PLAN COMMISSION

Wednesday, December 13, 2023 – 6:30 PM

From: Administrator/Staff
 To: Plan Commission
 Re: Public Hearing on a Conditional Use Application submitted by Utschig Inc on behalf of Last Time Realty LLC for a proposed heavy vehicle sales and rental development located adjacent to the west of 2615 West American Dr, specifically described as Tax ID #006-0341-02.

Plan Commission review & recommendation on a Site Plan Application submitted by Utschig Inc on behalf of Last Time Realty LLC for a proposed heavy vehicle sales and rental development located adjacent to the west of 2615 West American Dr, specifically described as Tax ID #006-0341-02.

L100

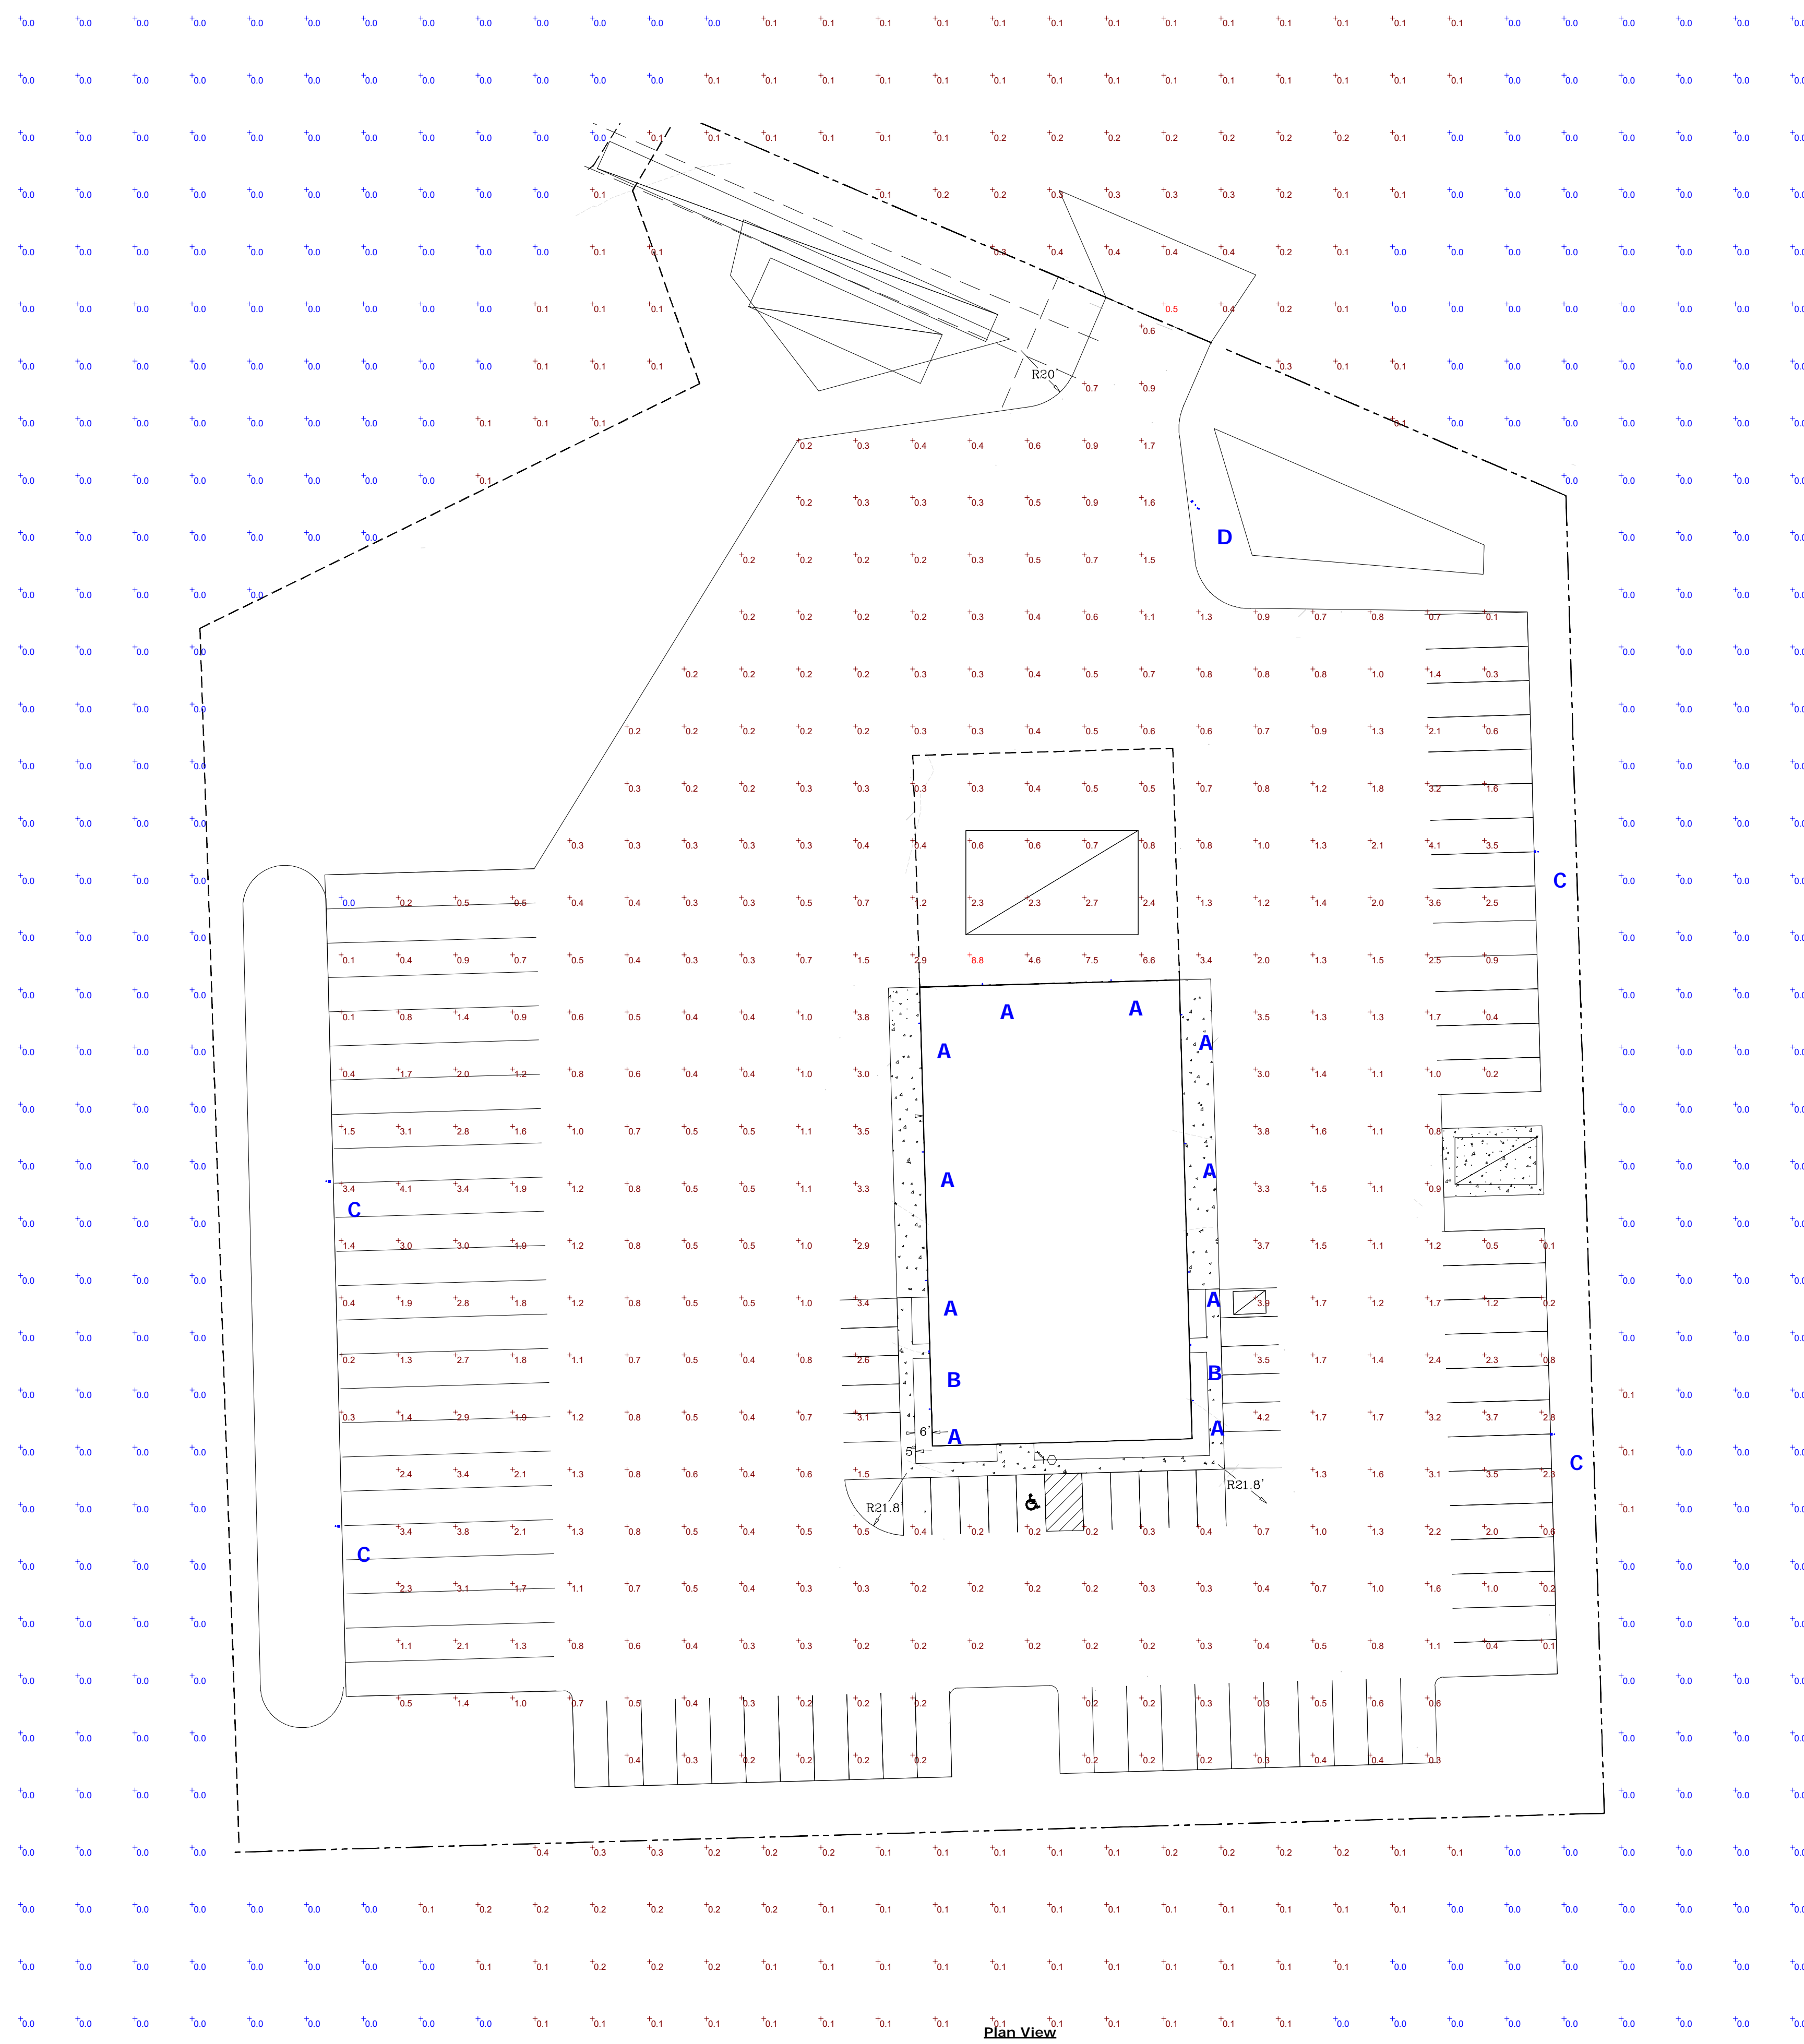
The Landscape Plan proposes an adequate number of evergreen trees around the perimeter of the parking lot. However, the evergreen trees are not equally spaced around the perimeter of the parking lot, particularly on the southern side of the parking lot.

Per Sec. C. (1) (d) 2), *“75% of all building sides must be landscaped with a variety of appropriate plant materials in a wood mulch or stone landscaping bed which is a minimum of 6’ wide measured from building façade.”*

The Landscape Plan does not comply with this requirement.

Plan Commission will need to review and determine if the parking lot perimeter landscaping is acceptable as proposed, or if the applicant will need to revise the landscape plan to adequately address this requirement.

- a. Per Attachment E, 75% of all building sides must be landscaped with a variety of appropriate plant materials in a wood mulch or stone landscaping bed which is a minimum of 6’ wide measured from building façade.
- b. 75% of all building sides are not landscaped due to overhead doors on the east and west sides of the building, and a planned future addition on the north side of the building.

Plan Commission will need to review and determine if the building landscaping is acceptable as proposed, or if the applicant will need to revise the landscape plan to adequately address this requirement.
